UNITED STATES PATENT AND TRADEMARK OFFICE

APPLICATION NO.	FILING DATE	FIRST NAMED INVENTOR	ATTORNEY DOCKET NO.	CONFIRMATION NO.
09/777,122	02/05/2001	Heinz Greiner	188.463	2422

Office Action Summary

DETAILED ACTION

FIG. 8

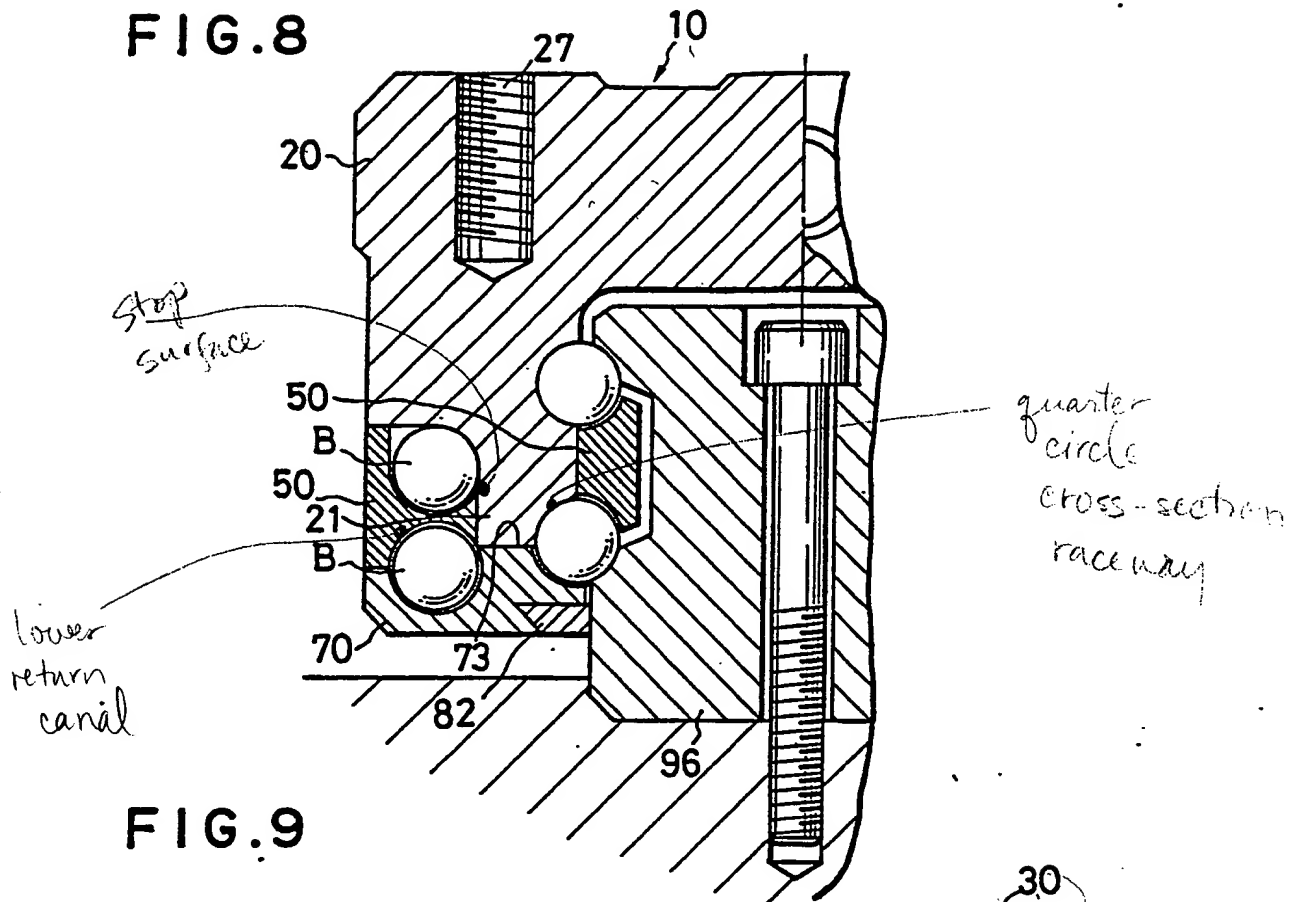
Re: claim 6, figure 8 shows the opening of the lower return canal to be smaller than the diameter of the balls inserted in the return canal (see attachment #1).
